ADDENDUM To

**Environmental Impact Study
Intracorp Phase V and VI Subdivision
Vales of Castlemore**

1281216 Ontario Inc.

November 2008

Figure 1. Undated aerial photo of Castlemore Golf Course property and surrounding area showing amphibian monitoring stations. Source: Google Earth 2007.

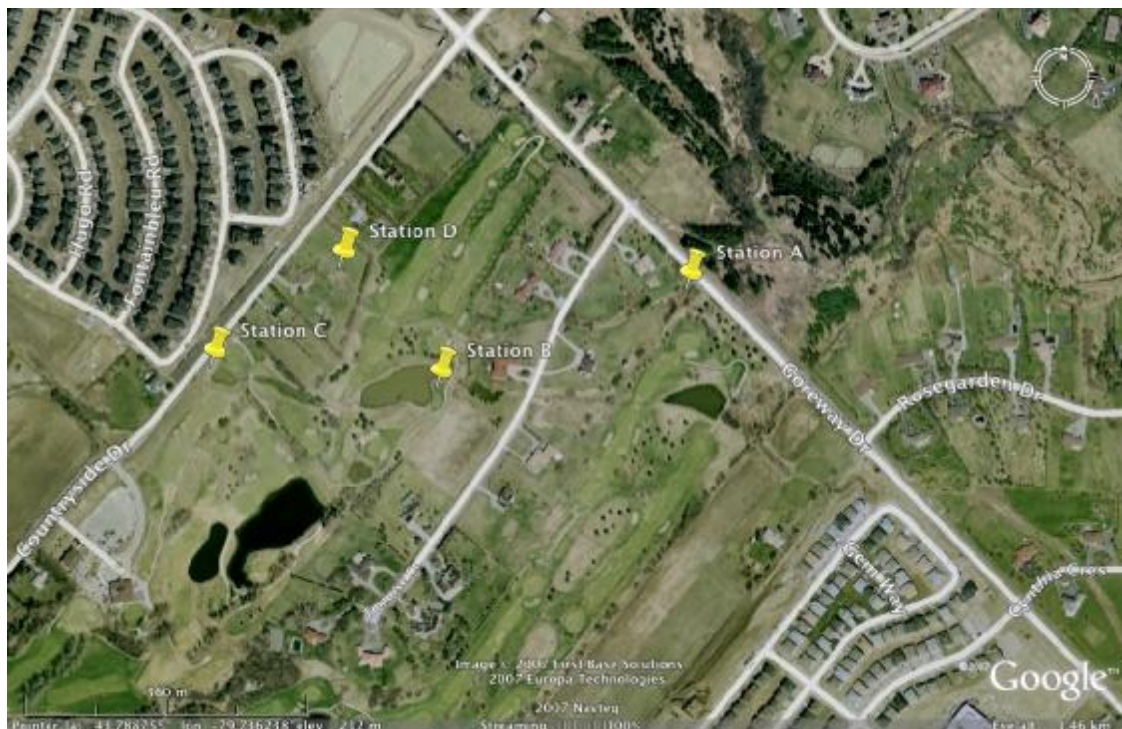
1. Details were lacking regarding the amphibian survey.

The Castlemore Golf Course was surveyed for amphibians (frogs and toads) over the entire breeding season. The survey was conducted by Heather Whitehouse M.Sc. and followed the Marsh Monitoring Program. The evening chosen was based on temperature cues (>5, >10, and > 17C) and low wind levels (Beaufort Scale 3 or less). All surveys were conducted at the appropriate standard time, no earlier than a half hour after sunset, and finished before midnight.

The site was visited on the evenings of April 24th, May 24th, and June 5, 2007. Four stations were visited based on the needs of the client (Station A thru D); see Figure 1. Calls were only heard from station B.

Over the course of three site visits, only *Rana clamitans* (Green Frog) calls were heard. The species name, call code (1-individual calls, 2-individual and small groups, and 3-full chorus), and number of individuals as recorded are included in Tables 1-3 herein.
